**CITY OF VAUGHAN**

**EXTRACT FROM COUNCIL MEETING MINUTES OF JUNE 25, 2013**

**SITE DEVELOPMENT FILE DA.13.023**

**YORK MAJOR HOLDINGS INC.**

## Master Plan

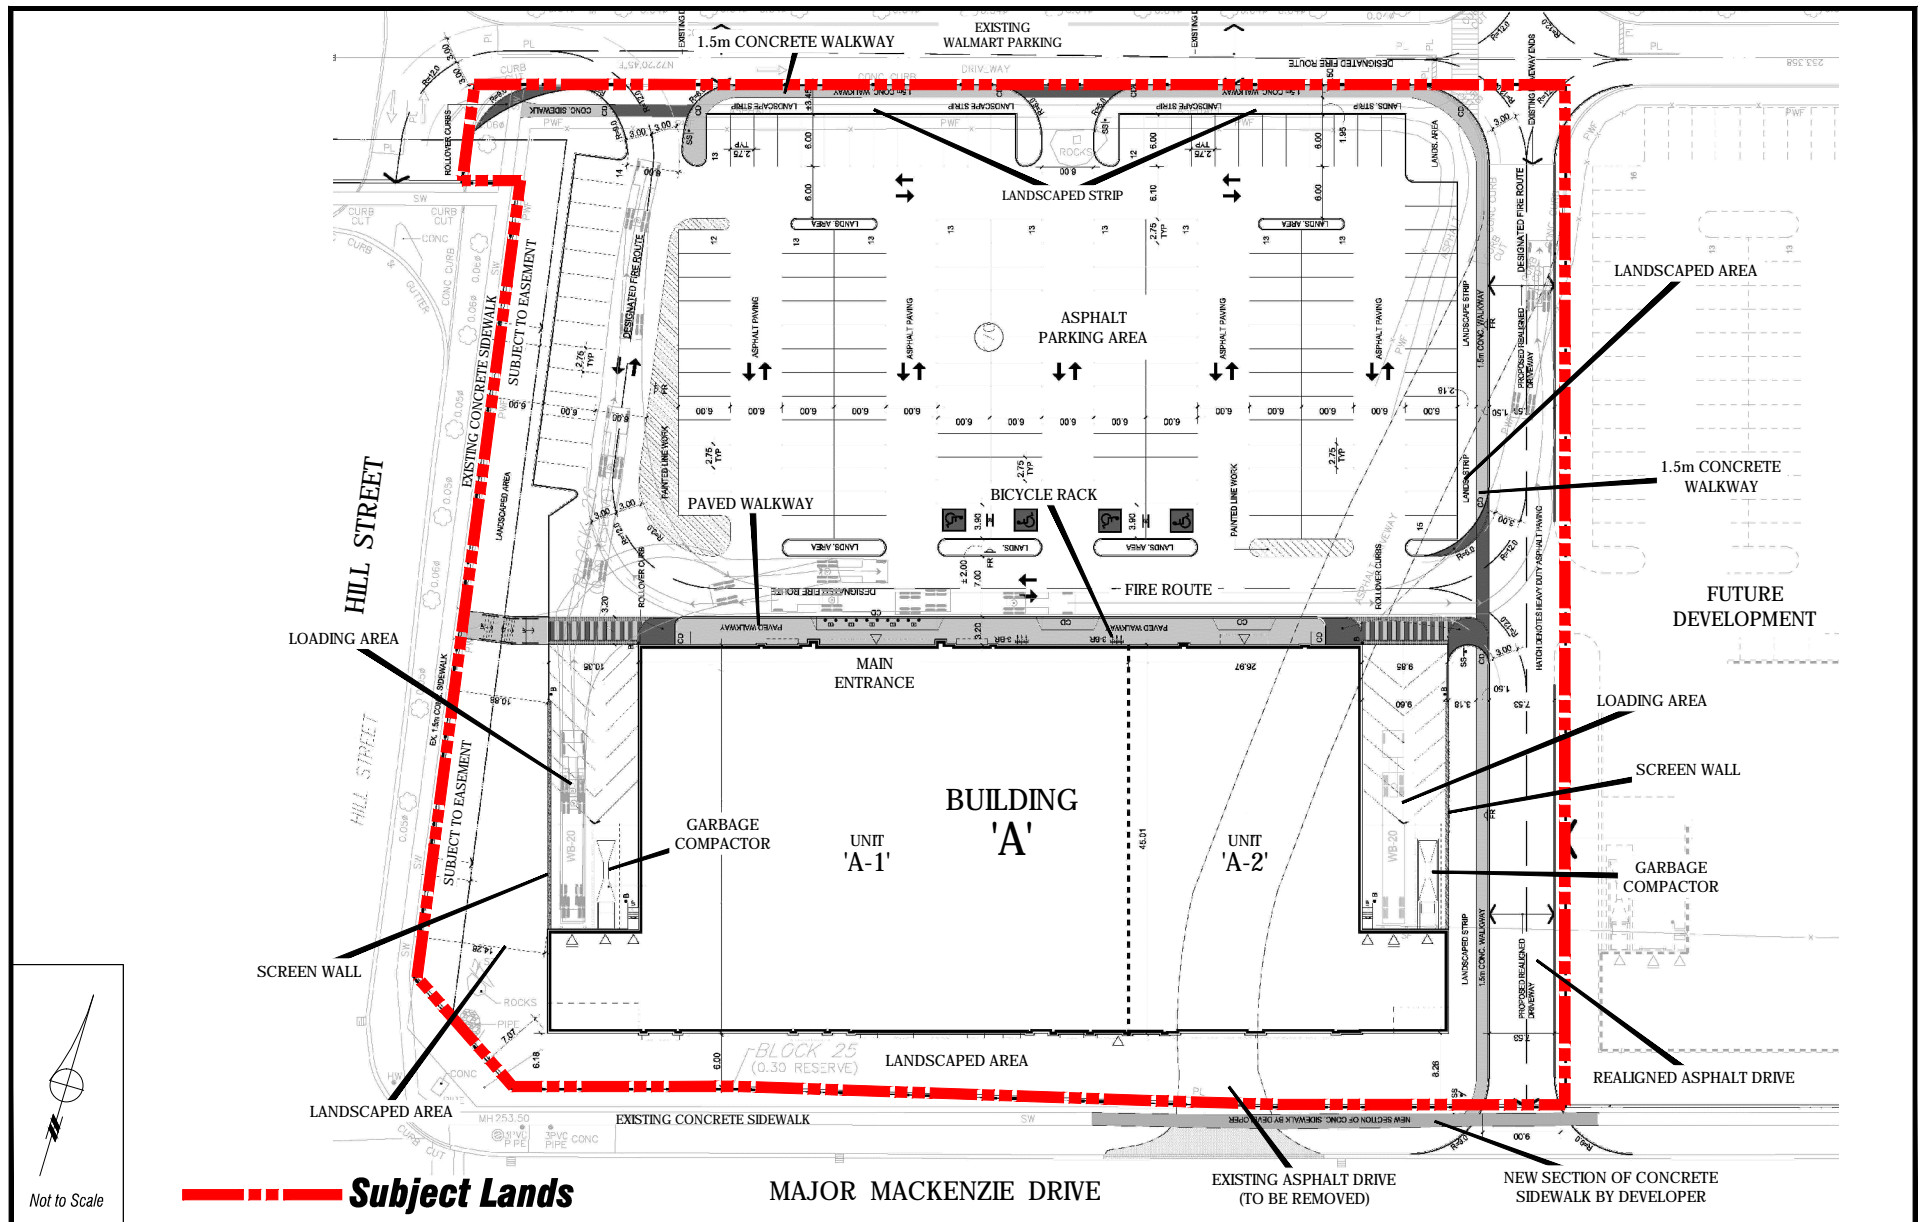
The subject lands are zoned M1 Restricted Industrial Zone by By-law 1-88, subject to Exception 9(1097), which permits the proposed retail / commercial development. In order to implement the proposed site plan shown on Attachment #3, the Owner has submitted Minor Variance Application A168/13 to the Vaughan Committee of Adjustment to permit the following site-specific exceptions to the M1 Zone of Zoning By-law 1-88:

The applicant had originally submitted a Traffic Impact Study prepared by Poulos, Chung dated March 2013, and applied for a Committee of Adjustment variance for a reduced averaged parking rate of 4.6 spaces / 100 m<sup>2</sup> across the entire block shown on the Master Plan on Attachment #3. The Minor Variance Application also included a variance for a reduced front yard setback from 9 m to 6 m along McNaughton Road. The Development Planning Department cannot support these specific Variances as there is no site plan application submitted on the portion of the applicant's other vacant lands to the east, and accordingly, there has been no review undertaken by Staff as to the appropriateness of these variances. Therefore, Staff can support the rationale for the parking rate of 4.24 (ie. 170 parking spaces) on the subject multi-unit development site in conjunction with the existing Wal-mart as discussed earlier. The applicant is advised to amend their Minor Variance Application to reflect the 4.24 rate on the multi-unit development parcel, and to remove the other two variances from consideration by the Vaughan Committee of Adjustment.

## Site Plan

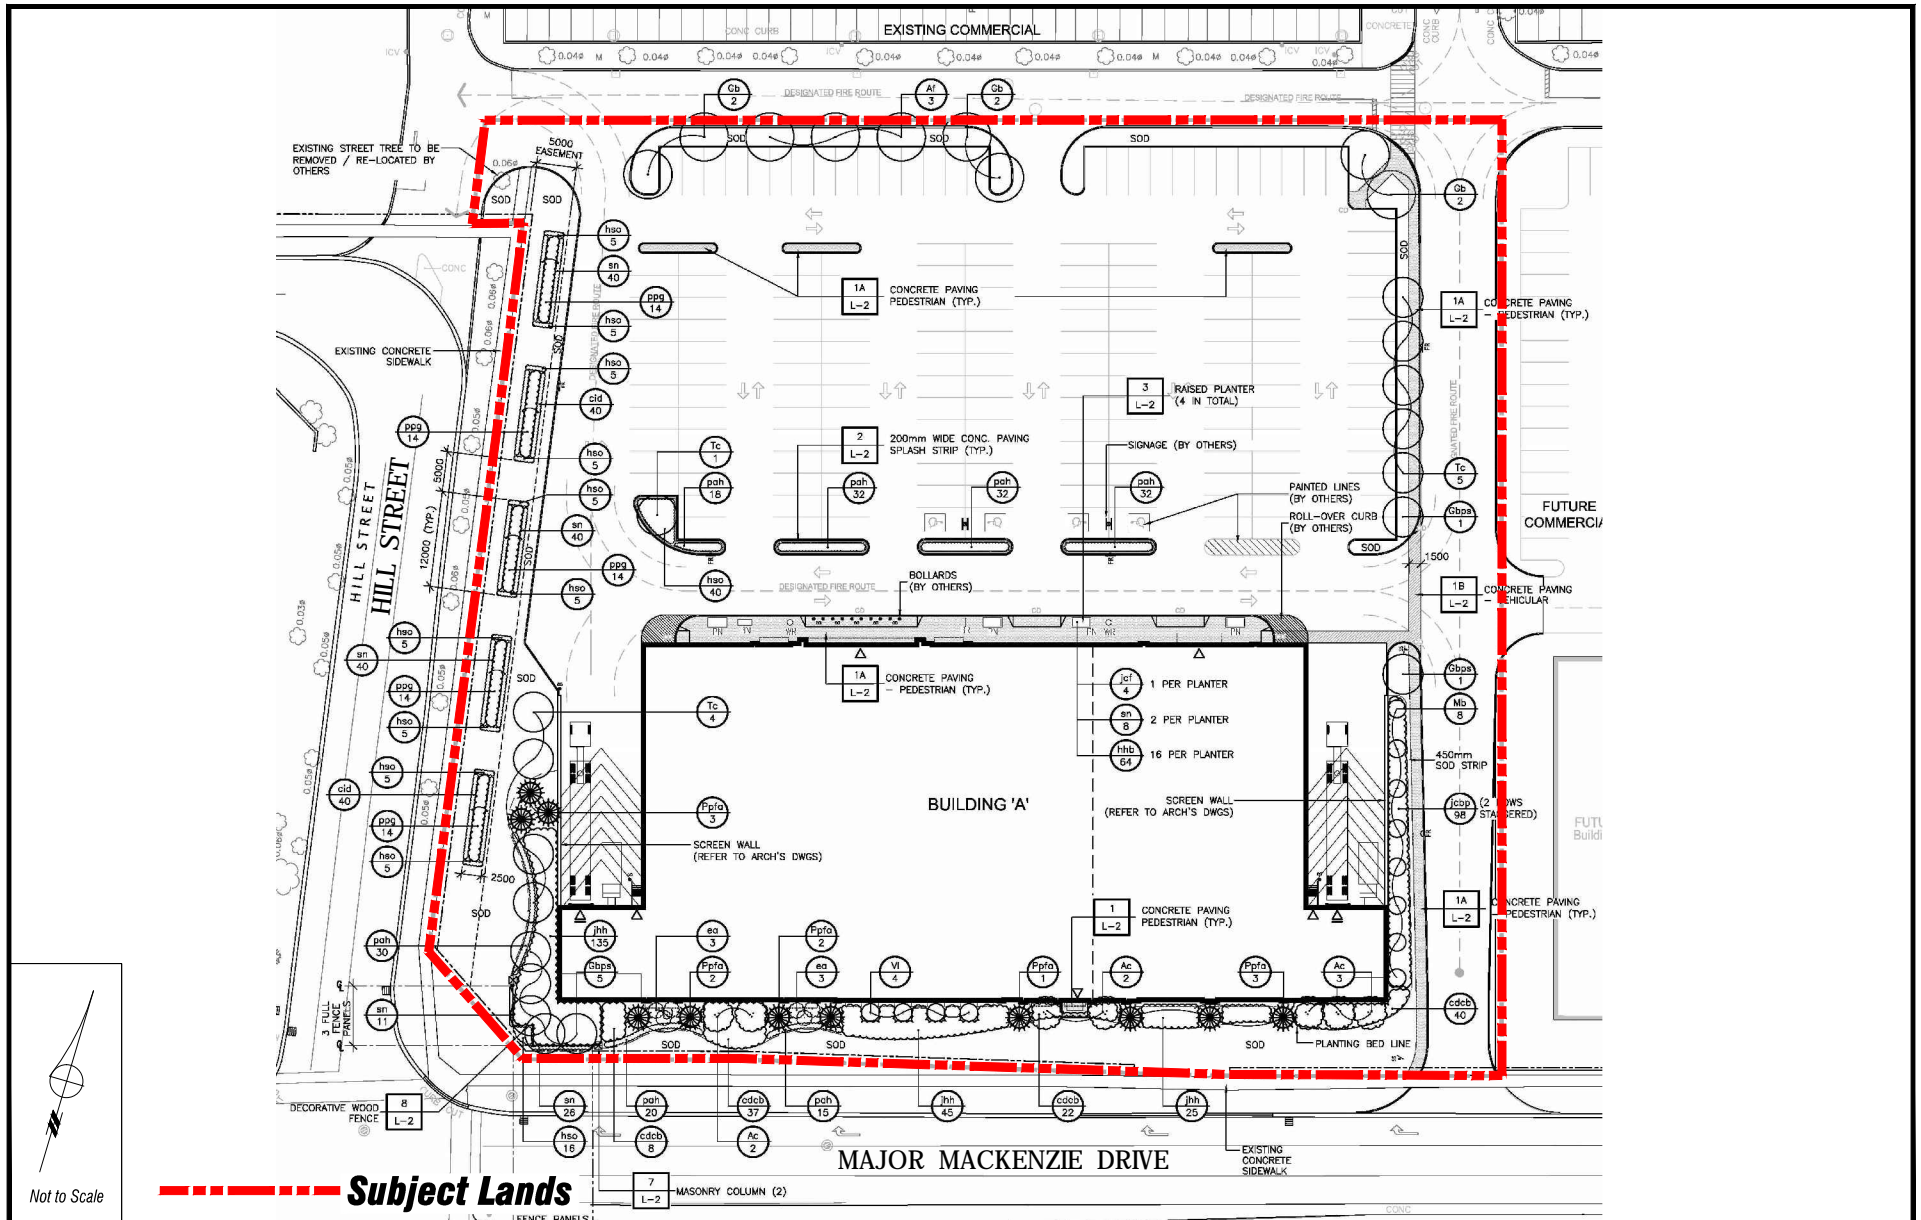
The 1.49 ha vacant site is part of a larger 8.92 ha land holding, that contains the existing Wal-Mart to the north and other vacant commercial lands that will be developed in the future, as shown on Attachment #3. The site plan shown on Attachment #4, proposes a 1-storey 2-unit retail / commercial building which will contain a Marshalls store in Unit A-1 and Unit A-2 will remain vacant until a tenant is secured. The 4,009.8 m<sup>2</sup> retail / commercial building is located on the southerly portion of the site with 2 loading spaces located on either side of the building and hidden by respective screen walls with materials / colours that complement the building, which are accessed from the internal parking lot and not visible from Major Mackenzie Drive. There is an existing driveway located on the property from Major Mackenzie Drive that is proposed to be removed.

i) Site Plan

- The proposed driveways must be constructed with heavy duty asphalt paving from the back edge of the municipal curb to the property line. This area should be highlighted on the site plan.
- The proposed right-in/out driveway at Major Mackenzie Drive should be designed to the satisfaction of the Region of York.

iv) Active Transportation / Pedestrian Access

- An additional sidewalk connection is proposed along the north border of the site (to replace the existing asphalt walkway). The availability of safe and continuous sidewalk connections between building entrances and surrounding destinations (e.g. Maple GO Station, Wal-Mart, etc.) encourages more people to walk between destinations; and,
- In addition to the sidewalk connection above, the driveway entrances to the parking lot provide an enhanced crossing (e.g. impressed asphalt) that continues at grade across the driveway.

# Landscape Plan

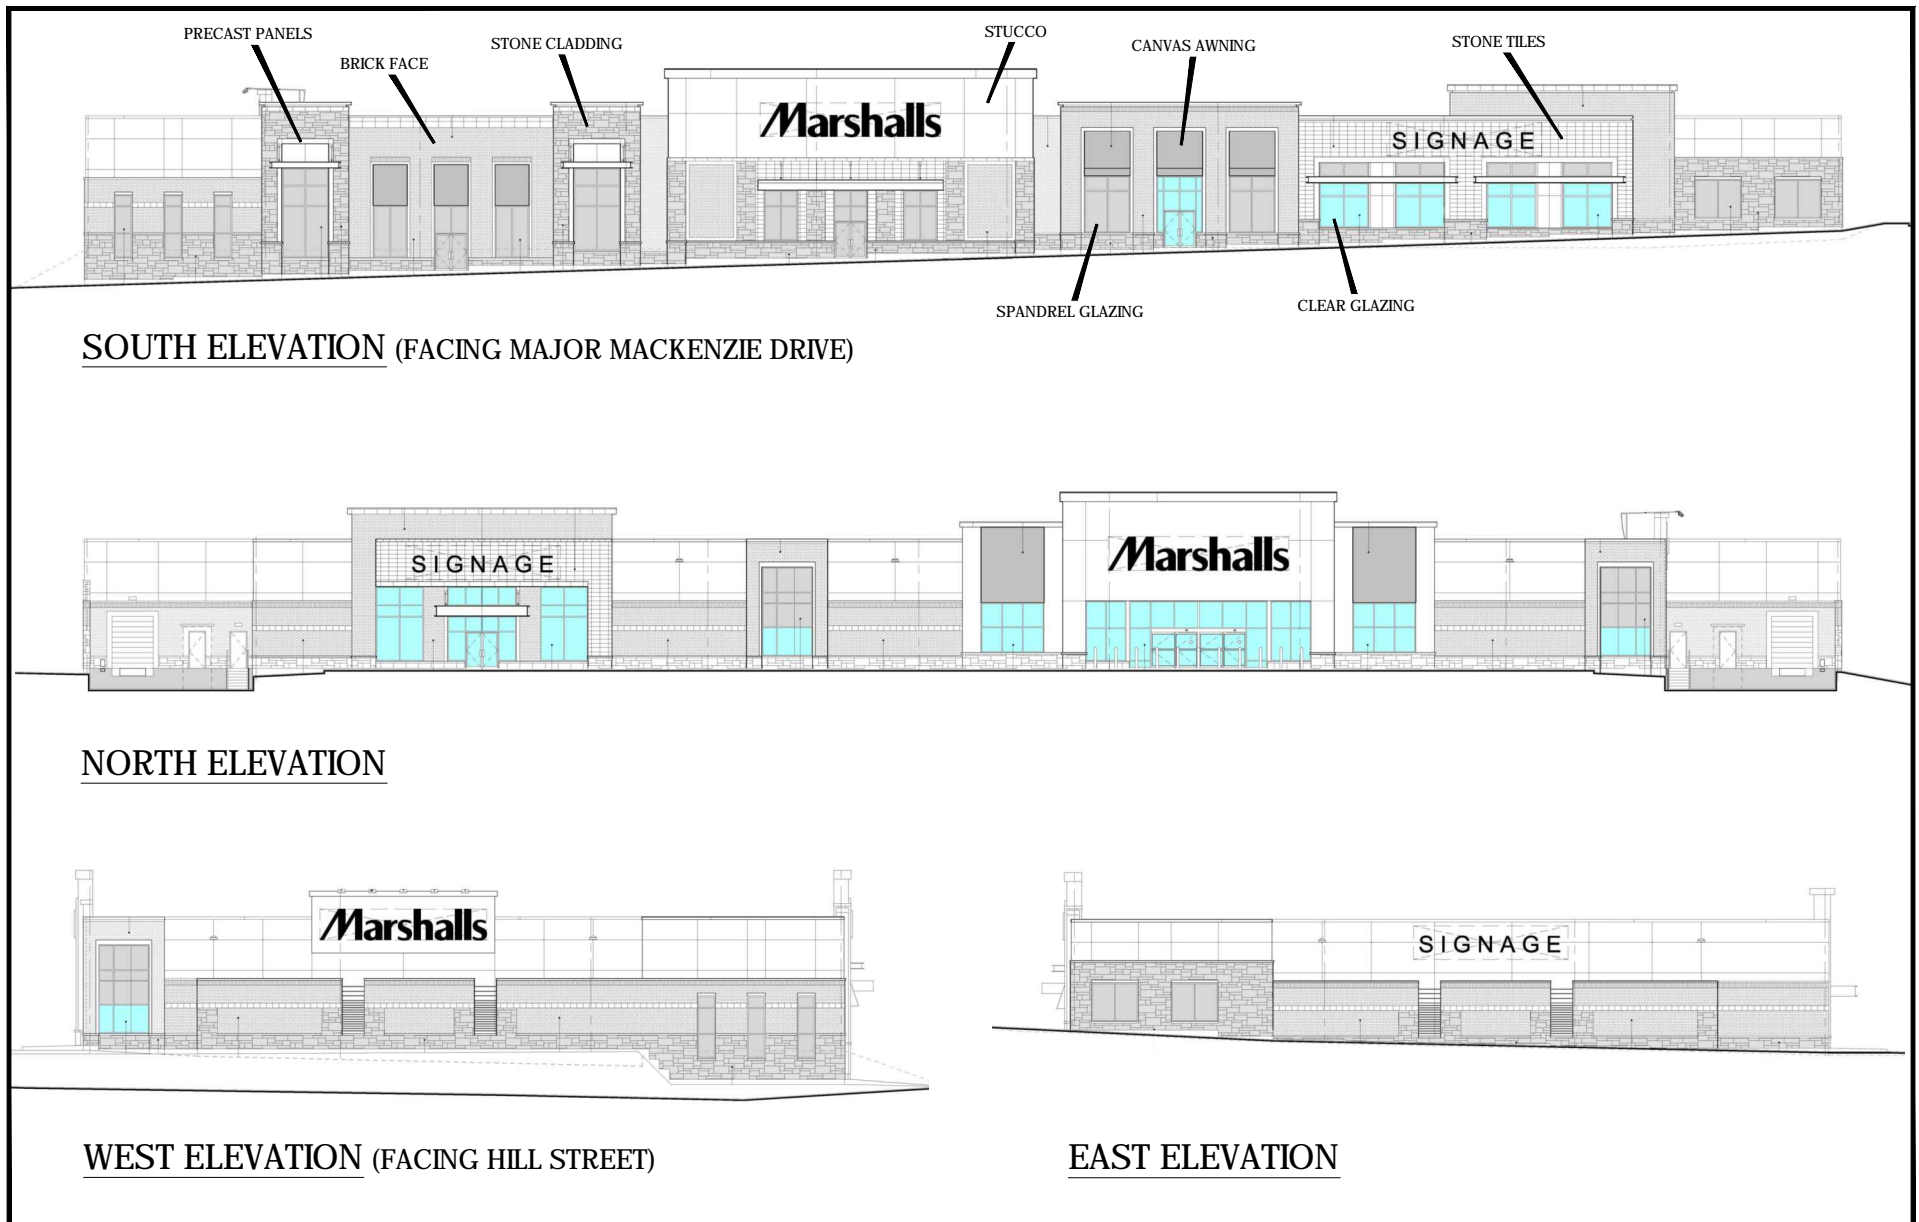
The landscape plan consists of a mix of deciduous and coniferous trees, shrubs, perennials, ornamental grasses and ground covers, as shown on Attachment #5. The Development Planning Department reviewed the landscape plan and recommended changes to the plan particularly along Major Mackenzie Drive. The landscape design abutting Major Mackenzie Drive must be in accordance with the design guidelines in the "Major Mackenzie Streetscape Study" dated April, 2010, which includes walkway connections. In response, the Owner has provided the Conceptual Landscape Plan shown on Attachment #6, which is acceptable to the Development Planning Department.

The landscape plan does not completely match the layout shown on the site plan, particularly along the west property line and the northwest corner of the site, and does not include all details such as a walkway across the north property line and bicycle racks. The final landscape plan must reflect the final approved site plan shown on Attachment #4, to the satisfaction of the Vaughan Development Planning Department.

Short term bicycle parking (for visitors) has been provided for at least six bicycles (as per the Draft Parking Standards Report, March 2010). All bicycle parking is shown on the Site Plan and must be shown on the Landscape Plan. The proposed rack/stand type should also be identified in the Landscape Details. Medium-high security stands are recommended, which permits the bicycle frame and both wheels to be locked to the rack. An inverted 'U' or swerve stand with in-ground mount is recommended.
